PRODUCT INFORMATION BULLETIN

Date: February 11, 2016
Number: 9620
Division: Genie®
Product Family: Residential Operators
Product Series: Screw Drive Models 4064, 3064, 2568 and 2564
To: All Genie Professional Line Wholesalers, Dealers and Installers
Re: Optical Encoder Replacement Service Kits

Screw Drive Models 2564 / 2568 / 3064 / 4064

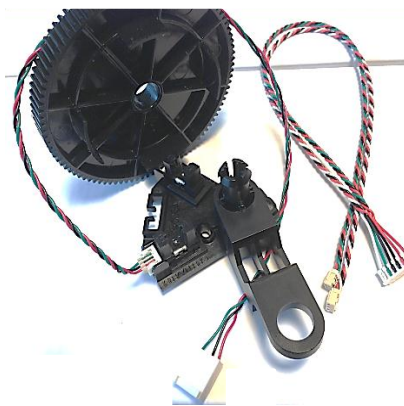
New Optical Encoder Replacement service kits (for both single and dual encoder boards) are available for Screw Drive Models 4064, 3064, 2568 & 2564.

Replacing the optical encoder on the screw drive operators cannot be easily performed while the unit is installed. It is recommended to remove the motor from the unit before replacing the optical encoder. If you choose to use the encoder kits, you will find the required part number above and a link to the instructions.

The Optical Encoder Replacement Kits come prepared for a single encoder board and has the single encoder opto cable (4-pin connection) pre-assembled to the encoders. The dual encoder opto cable (6-pin board connection) will be placed into the kit separately should it be needed. See the Opto Harness details inside the linked instructions for further detail.

Can be Used on	Action	Kit Part Number	Instructions
Model 2564 / 2568 AC Screw Drive	Replace optical encoder assembly <i>(Single and Dual Encoder Material Included)</i>	39153R.S	AC Instructions
Model 3064 / 4064 DC Screw Drive	Replace optical encoder assembly <i>(Single and Dual Encoder Material Included)</i>	39155R.S	DC Instructions
